UNITED STATES PATENT AND TRADEMARK OFFICE

APPLICATION NO.	FILING DATE	FIRST NAMED INVENTOR	ATTORNEY DOCKET NO.	CONFIRMATION NO.
10/807,226	03/23/2004	William Fredrick Tschirlig JR.	4418-121 US	3308
26817	7590	02/09/2006		
MATHEWS, SHEPHERD, MCKAY, & BRUNEAU, P.A. 100 THANET CIRCLE, SUITE 306 PRINCETON, NJ 08540				
			EXAMINER GABLER, PHILIP FRANCIS	
			ART UNIT	PAPER NUMBER
			3637

Office Action Summary	Application No.	Applicant(s)	
	10/807,226	TSCHIRLIG, WILLIAM FREDRICK	
	Examiner	Art Unit	
	Philip Gabler	3637

DETAILED ACTION

McIlwraith '393 Figures 1 and 2

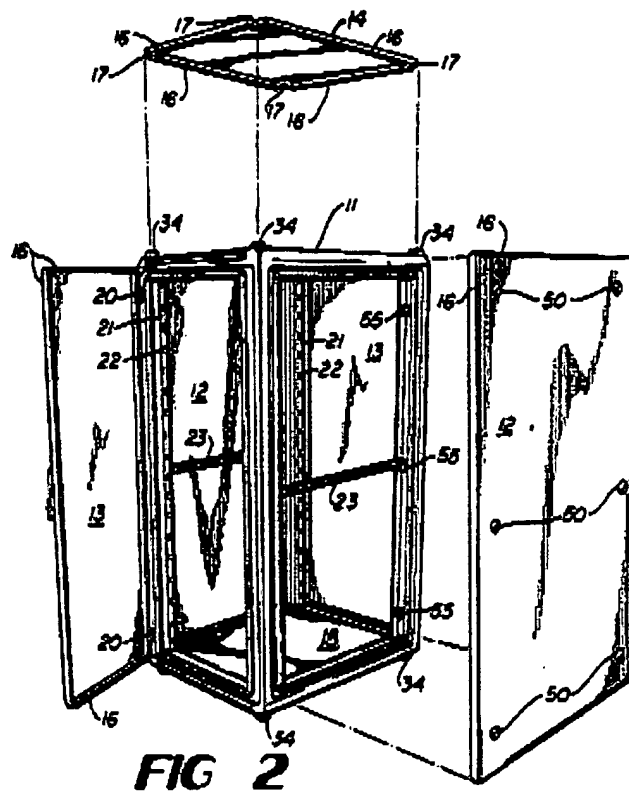
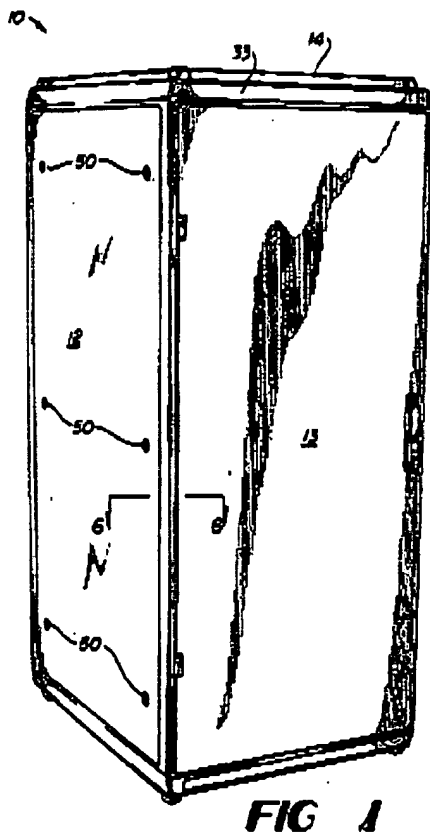
10. Claims 1, 4-6, 10 and 12-15 rejected under 35 U.S.C. 102(b) as being anticipated by McIlwraith (US Patent Number Re 34393). McIlwraith (Figures 1-6) discloses a cabinet capable of being mounted in a bathroom comprising: a cabinet body (10) capable of being mounted on a wall having an internal storage area (interior of 10) capable of receiving items and a cabinet body lip (31); the cabinet body comprising a top sidewall (14), a bottom sidewall (15), a hinge sidewall and a non-hinge sidewall

(both labeled 12), the top sidewall connected to the hinge sidewall by a first corner structural element, the top sidewall connected to the non-hinge sidewall by a second corner structural element; the bottom sidewall connected to the hinge sidewall by a third corner structural element, the bottom sidewall connected to the non-hinge sidewall by a fourth corner structural element (all of the corner structural elements are labeled 26); a cabinet door (13) pivotally mounted to said cabinet body; and a cabinet seal (40) coupled to the cabinet body lip; wherein the cabinet seal substantially covers the outer cabinet body lip.

11. Regarding claim 4, McIlwraith discloses the corner structural elements are connected to the corresponding sidewall by fasteners (50 and 56, via elements 27 and 25).

12. Regarding claim 5, McIlwraith further discloses a screw (56).

13. Regarding claim 6, McIlwraith further discloses the cabinet seal is coupled to the cabinet body lip by snapping over the lip (column 5 lines 62-63).

14. Regarding claim 10, McIlwraith further discloses a plurality of corner caps (25) wherein the corner caps are attached to corresponding corner structural elements such that the corner cap is essentially flush with the cabinet body lip.

15. Regarding claim 12, McIlwraith further discloses the corner caps are integral to the corner structural elements.

16. Regarding claim 13, McIlwraith further discloses the cabinet seal is a generally pliable material (i.e. rubber, column 5 lines 46-47).

17. Regarding claim 14, McIlwraith further discloses the material is polymeric (again, rubber, column 5 lines 46-47).

18. Regarding claim 15, McIlwraith further discloses the material is at least partially hollow (see Figure 5).

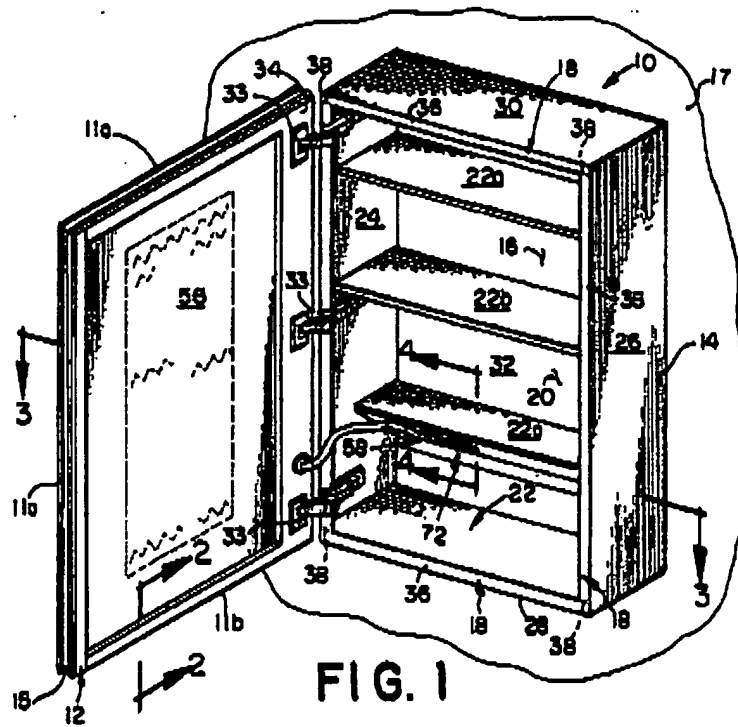
23. Regarding claims 1, 8, 16, and 17, Katz (Figures 1 and 3) discloses a cabinet capable of being mounted in a bathroom comprising: a cabinet body (14) capable of being mounted on a wall having an internal storage area (16) capable of receiving items and a cabinet body lip (formed by 24a, 26a, and the corresponding top and bottom flanges not shown but mentioned in column 4 lines 30-34); the cabinet body comprising a top sidewall (30), a bottom sidewall (28), a hinge sidewall (24) and a non-hinge sidewall (26) each having a channel (24b, 26b, and channels in the top and bottom sidewalls not shown but mentioned in column 4 lines 28-30); a cabinet door (12) pivotally mounted to said cabinet body; a cabinet seal (36) coupled to the cabinet body lip; wherein the cabinet seal substantially covers the outer cabinet body lip; and a back support (32) held by the sidewall channels. [Note that the back support of claim 8 is viewed as being a positively recited claim limitation despite being introduced in

functional language (i.e. "to hold...").] Katz does not disclose corner structural elements.

Katz '627 Figure 1

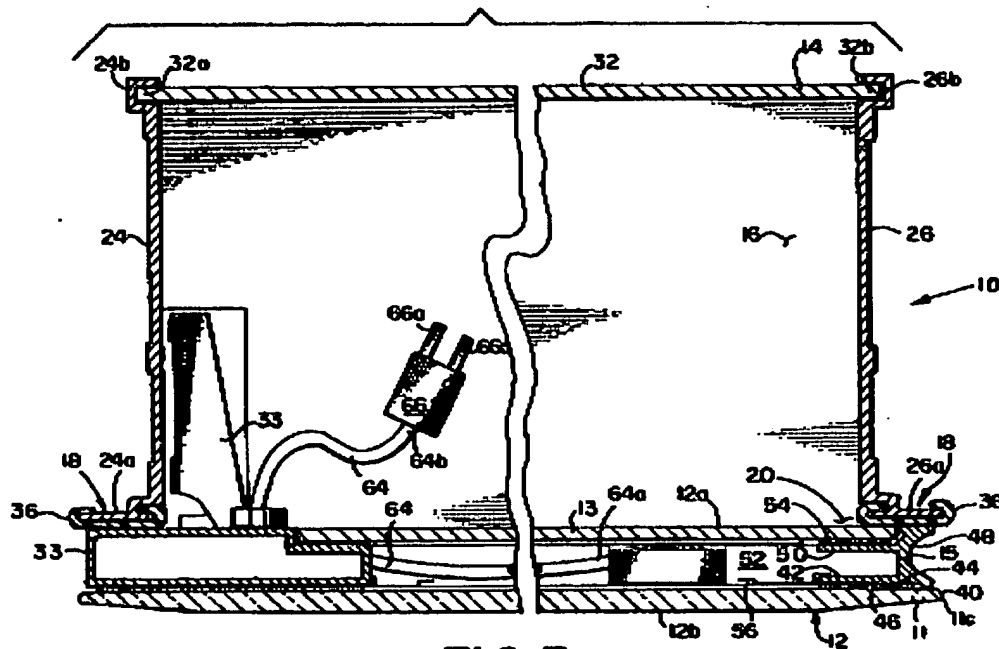
24. Regarding claims 2 and 18, Katz further discloses the use of aluminum for construction of the cabinet (column 3 line 65 to column 4 line 1).

26. Regarding claims 6 and 20, Katz further discloses the cabinet seal is coupled to the cabinet body lip by snapping over the lip (column 5 lines 31-33).

27. Regarding claims 7 and 21, Katz further discloses the cabinet seal could be coupled to the cabinet body by adhesive (column 5 lines 34-37).

Gilinger '344 Figures 2 and 3

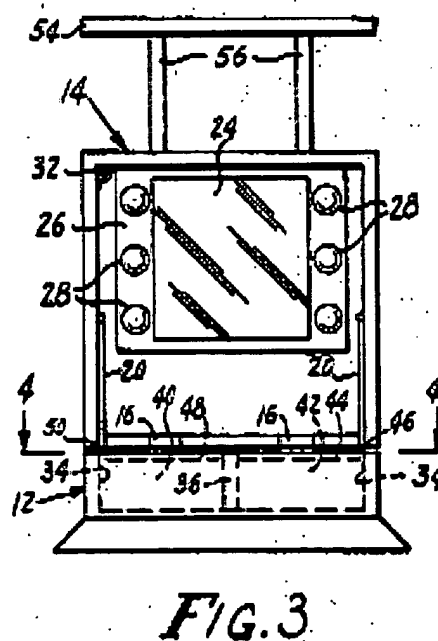
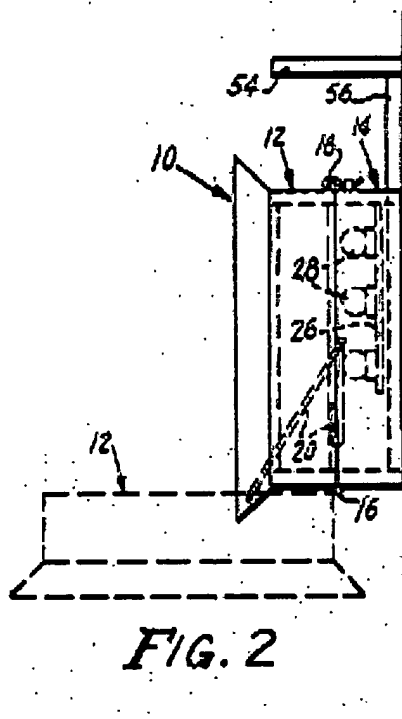
28. Claim 9 is rejected under 35 U.S.C. 103(a) as being unpatentable over Katz in view of Peterson and further in view of Gilinger (US Patent Number 3684344). Katz, when modified by Peterson as described above, discloses a cabinet as recited in claim 8 but does not disclose an interior mirror mounted to a back support. Gilinger (Figures 2 and 3) discloses a cabinet with an interior mirror (24) mounted to a back support (area 26 of section 14). Accordingly, it would have been obvious to one of ordinary skill in the art at the time the invention was made to modify Katz's cabinet, previously modified by Peterson, to include an interior mirror as taught by Gilinger because this arrangement would provide an additional convenience to the cabinet.
